**RESPONSE TO COMMENTS  
NPDES PERMIT NO. MAG590000  
MEDIUM WASTEWATER TREATMENT FACILITY GENERAL PERMIT**

The U.S. Environmental Protection Agency's New England Region (EPA) is issuing a Final National Pollutant Discharge Elimination System (NPDES) General Permit for Medium Wastewater Treatment Facilities (WWTFs) located in Massachusetts. This permit is being issued under the Federal Clean Water Act (CWA), 33 U.S.C., §§ 1251 *et seq.*

In accordance with the provisions of 40 Code of Federal Regulations (CFR) §124.17, this document presents EPA's responses to comments received on the Draft NPDES General Permit # MAG590000 ("Draft General Permit"). The Response to Comments explains and supports EPA's determinations that form the basis of the Final General Permit. From February 8, 2022, through April 26, 2022, EPA solicited public comments on the Draft General Permit.

**Figure 1**  
Annual Minimum 7-day Average Flow Normalized by Drainage Area for Three Gages near Northbridge

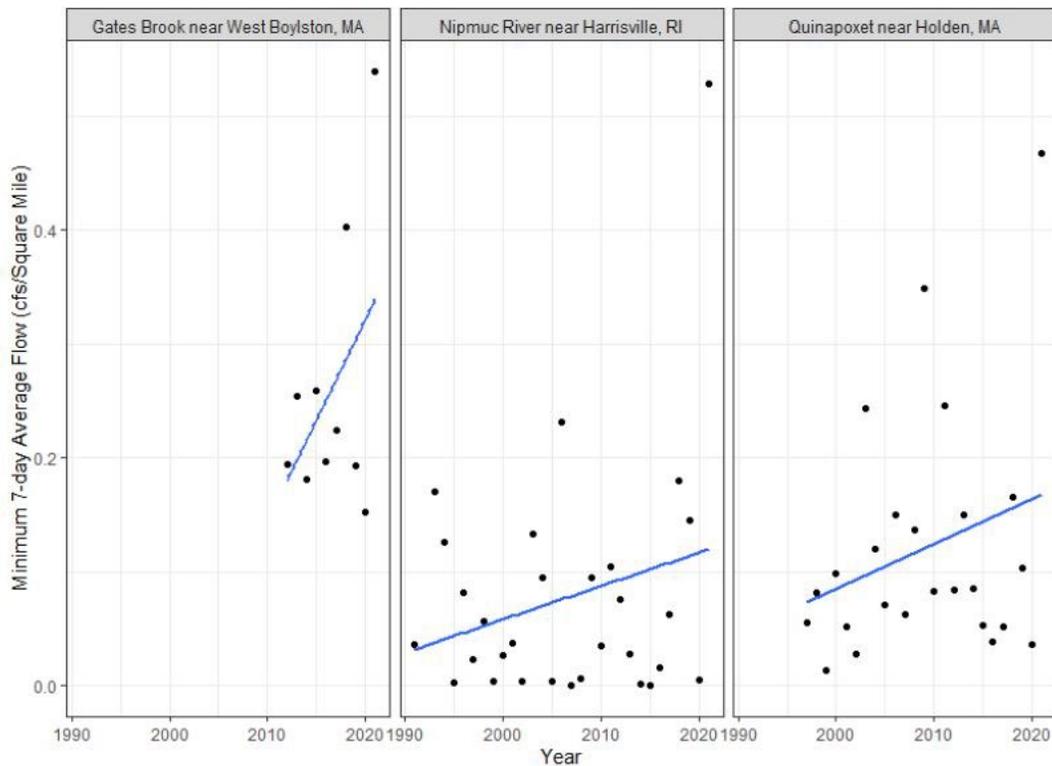
For each gage, the minimum 7-day average flow was calculated between 1991 and 2021 for each year and plotted to evaluate whether regional hydrologic changes would support such a significant reduction in the 7Q10 flow<sup>3</sup>. This analysis (**Figure 1**) indicates that the 7-day average low flow exhibits an upward trend at all four gages. This assessment therefore indicates that regional baseflow has not been trending down since the previous permit was issued in 2012, and does not support the nearly two orders of magnitude reduction in 7Q10 flow indicated by EPA’s revised analysis in this Draft General Permit.

Figure 2  
7Q10 Analysis for USGS 01095434 Gates Brook near West Boylston MA

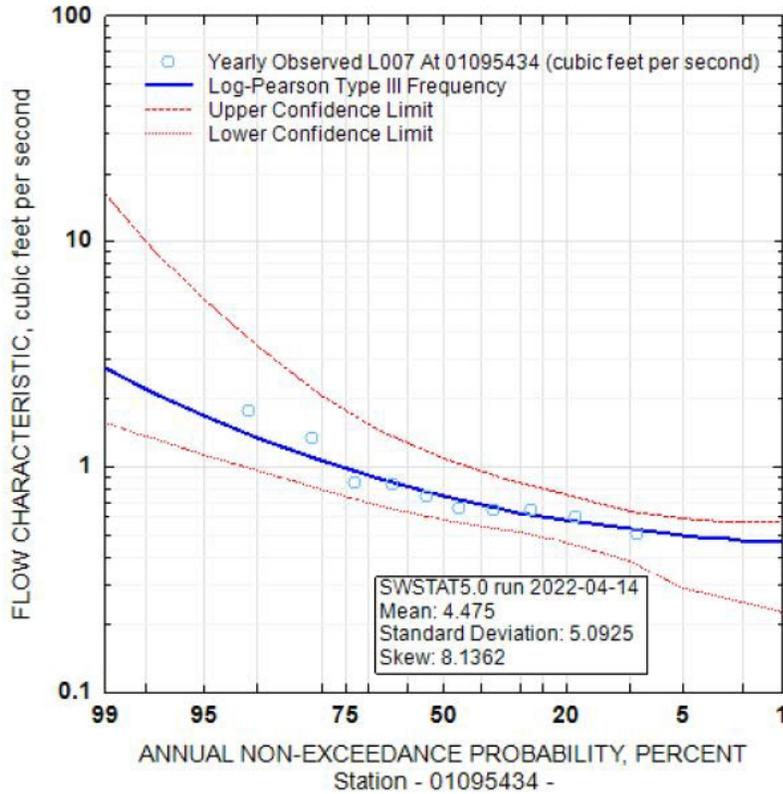
- Using standard calculation techniques with a Log-Pearson Type III fit to the streamflow data (using USGS SW Toolbox version 1.0.5)
- Using the regression equations in StreamStats. The calculated 7Q10 for this gage is 0.525 cfs, with a 95% confidence interval of 0.379 – 0.631 cfs (**Figure 2** and **Attachment 2**).

Based on the USGS-reported drainage area for the Gates Brook gage (3.13 mi<sup>2</sup>), the 7Q10 flow is 0.168 cfs/mi<sup>2</sup> with a 95% CI of 0.121 – 0.202 cfs/mi<sup>2</sup>. Scaled to the drainage area of the unnamed tributary (1.45 mi<sup>2</sup>) the Northbridge discharge would represent a 7Q10 flow between 0.18 and 0.29 cfs – lower than the current 7Q10 flow, but not a decrease of an order of magnitude that is proposed in the Draft General Permit. Furthermore, for Gates Brook, the calculated 7Q10 and estimated 7Q10 using StreamStats vary by an order of magnitude here, as well, suggesting that the StreamStats estimate is not a reliable calculation for the 7Q10 flow for small streams in this region.

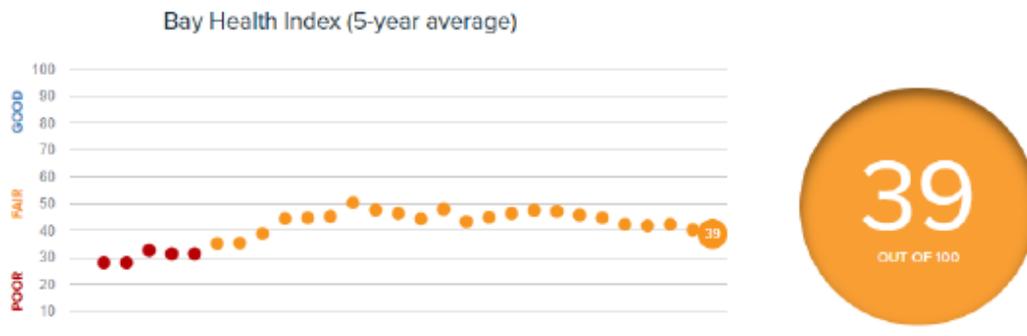
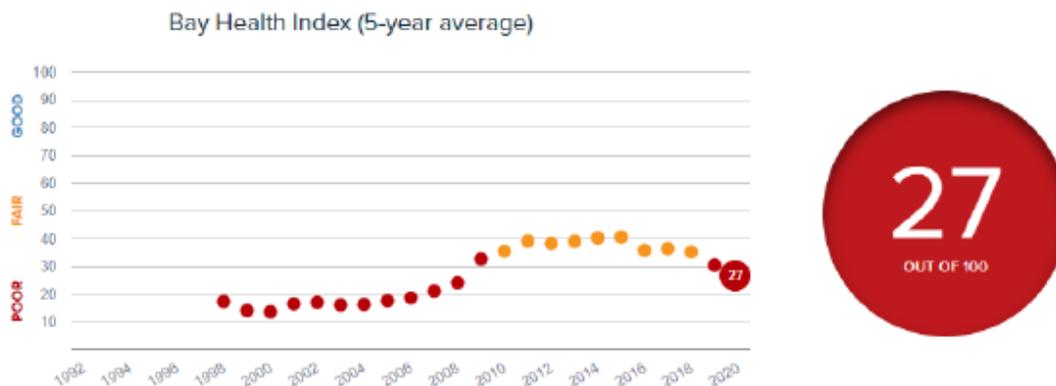
More than thirty years of EPA-approved Coalition water quality monitoring data indicate significant nitrogen impairment in estuaries across Buzzards Bay.<sup>1</sup> It is well established that nitrogen pollution, primarily from wastewater, is the greatest long-term threat to the health of Buzzards Bay waters. Nearly all of the more than 30 harbors and coves in Buzzards Bay are

More than thirty years of EPA-approved Coalition water quality monitoring data indicate significant nitrogen impairment in estuaries across Buzzards Bay.<sup>1</sup> The Coalition’s Bay Health Index measures the nutrient-related health of more than 100 harbors, coves, salt ponds and rivers throughout Buzzards Bay and Vineyard Sound. The index is a snapshot of the Bay’s health with 100 indicating pristine water and 0 representing severe nitrogen pollution.
